**Ironbound Road Mini-Storage**

*BMP Design & Hydrology/Hydraulics*

*SP-45-98  
(APPROVED 3-09-99)*

Re: Ironbound Mini-Storage (Plan No. SP-45-98)  
Ironbound Road  
Stormwater Management/BMP Facilities # 1 & # 2  
*(MC 032) & (MC 033)*

**DRAINAGE AND UTILITY PLAN**  
**IRONBOUND ROAD**  
**MINI STORAGE**  
 OWNER/DEVELOPER: BERNARD J. LEVEY  
 JAMES CITY COUNTY, VIRGINIA

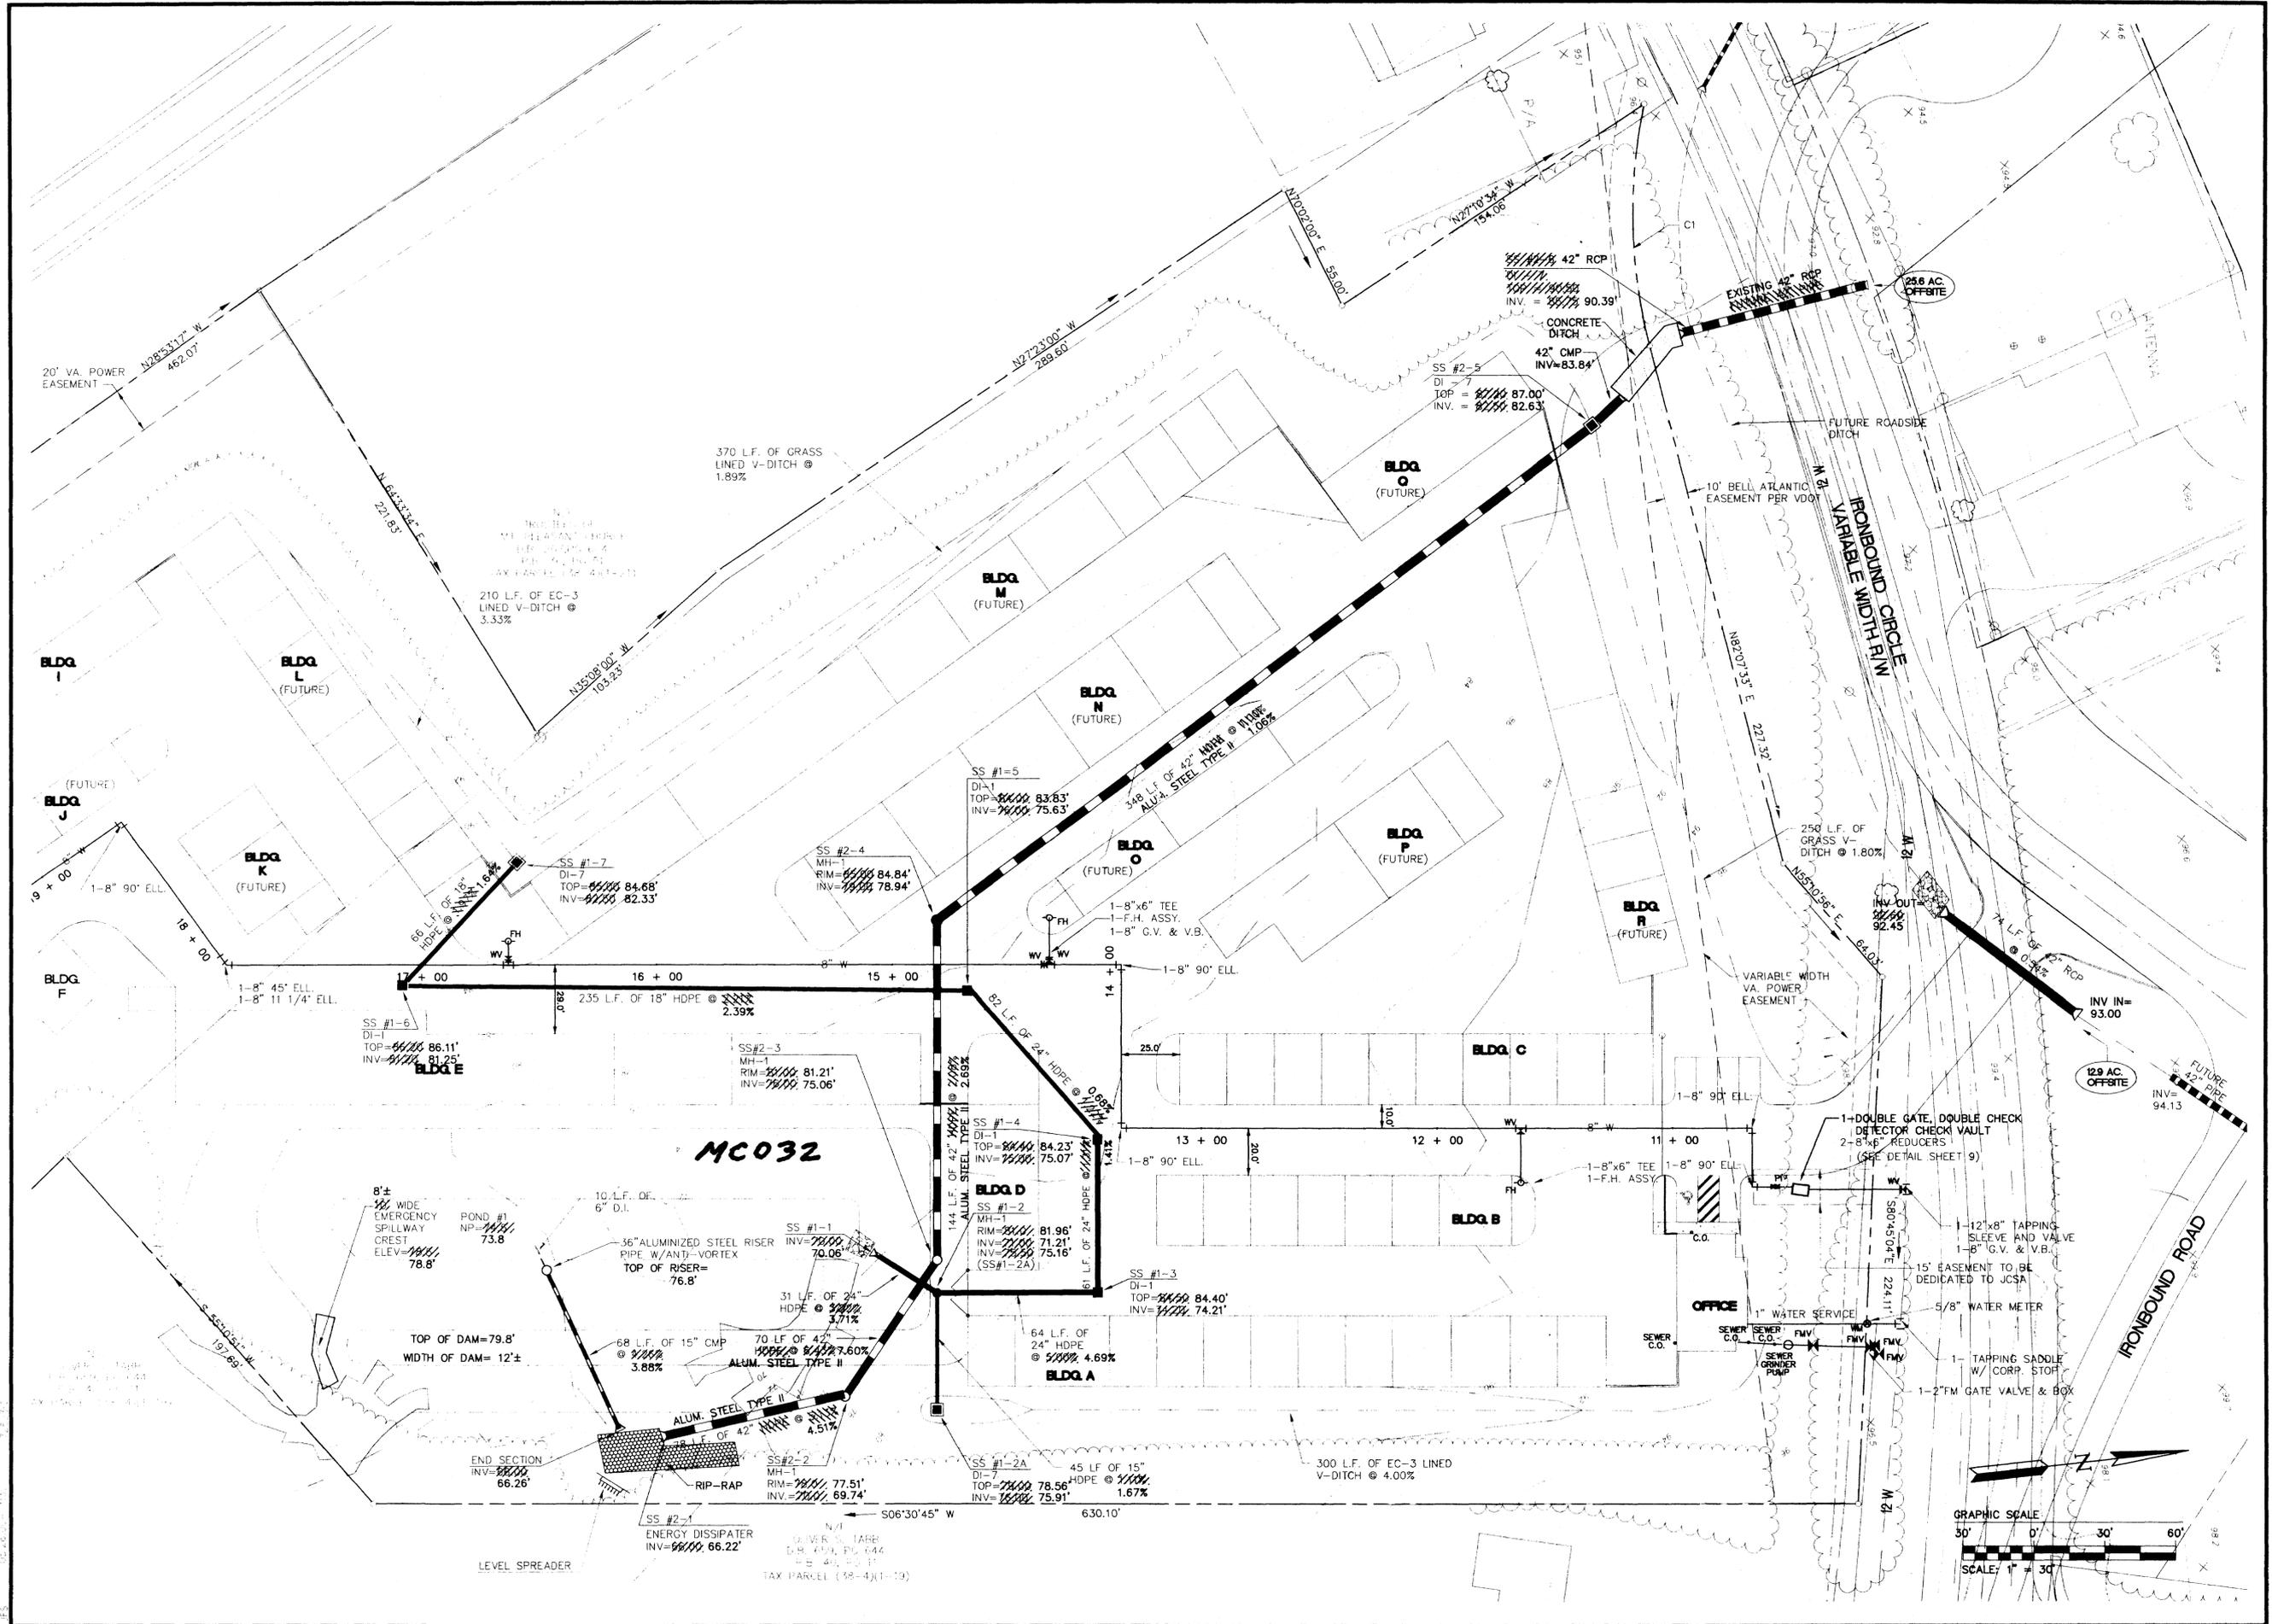
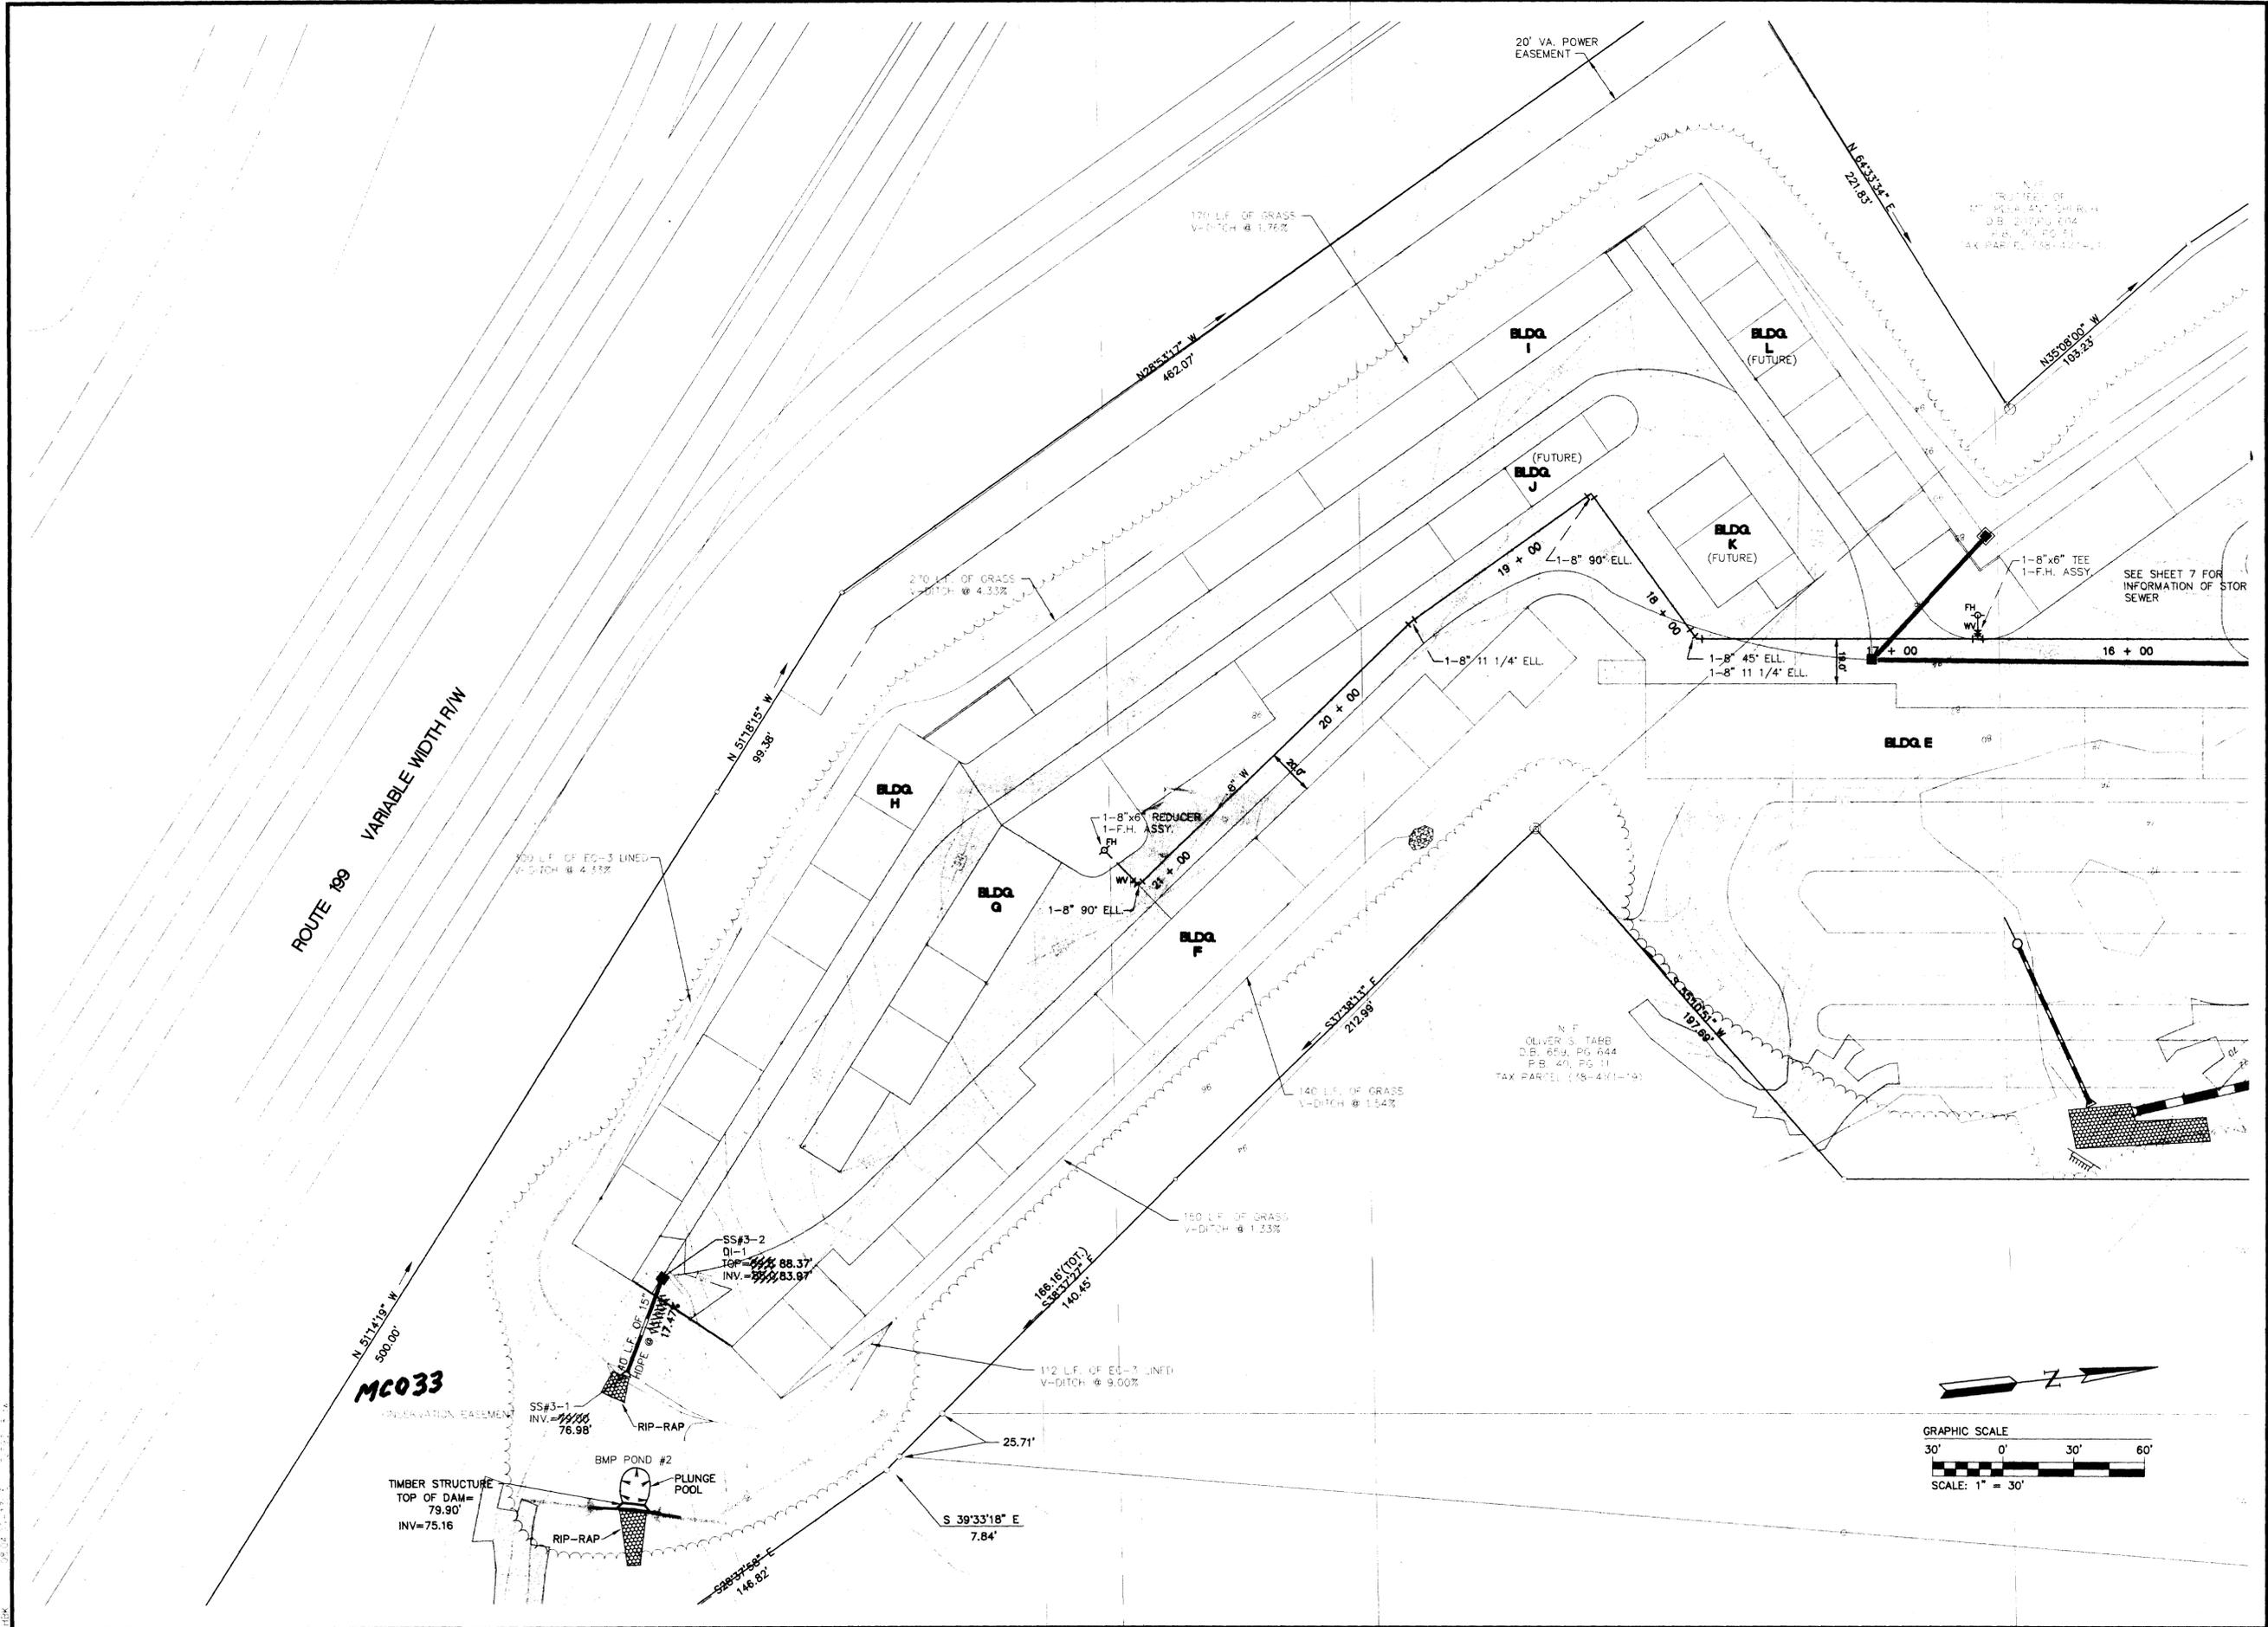
3. Wet Pond # 1. The as-built elevation of 66.26 for the pond barrel outlet (end section) would result in an as-built pond barrel slope different from that of the approved design plan (4.26 percent). Make this correction on the record drawings as necessary.

Designed	HWP/CAH	Drawn	EAW
Scale	NONE	Date	4/98
Project No.	7259-3	Drawing No.	14

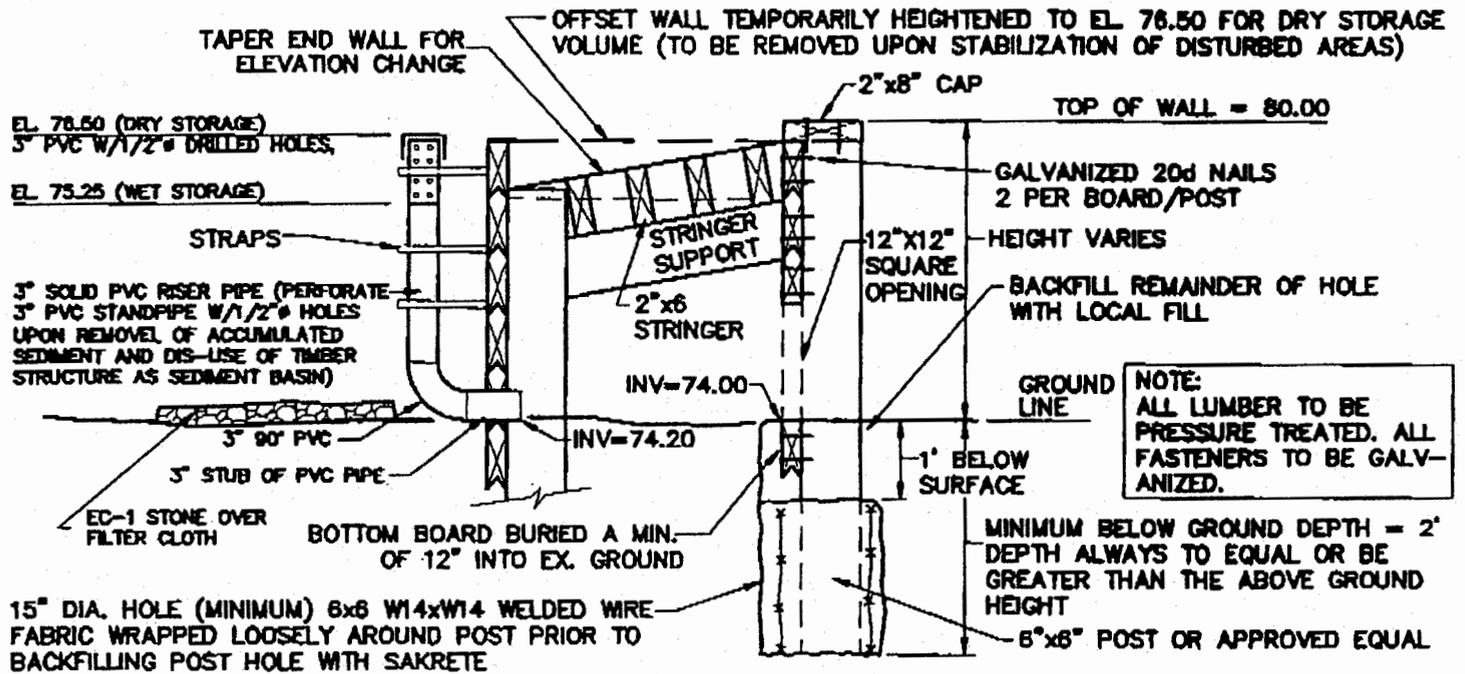
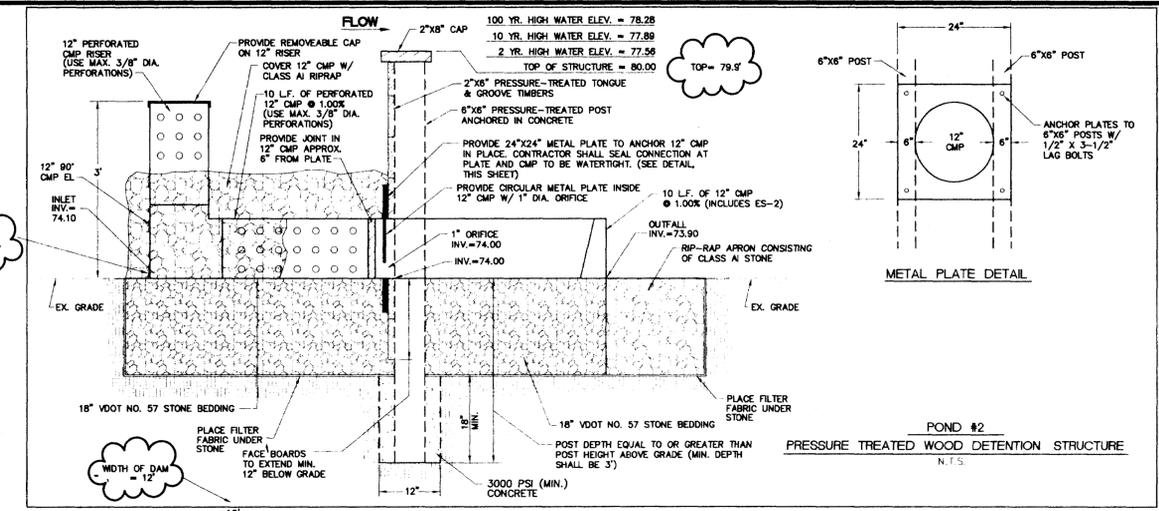
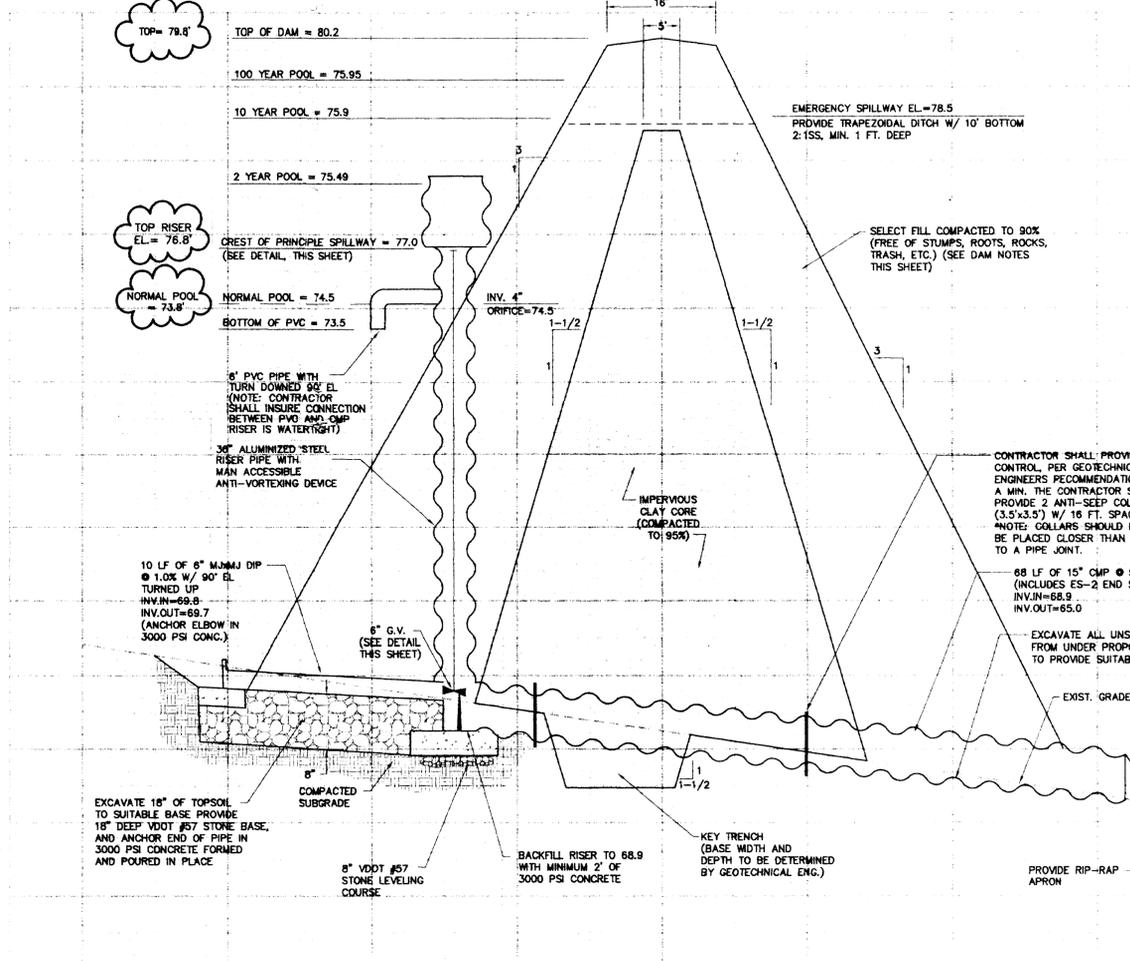
2. Add Sheet # 14 of the approved design plan set, annotated as necessary, to the record drawing set. This sheet shows specific profiles and details relative to the two facilities and maintenance requirements for the facilities.
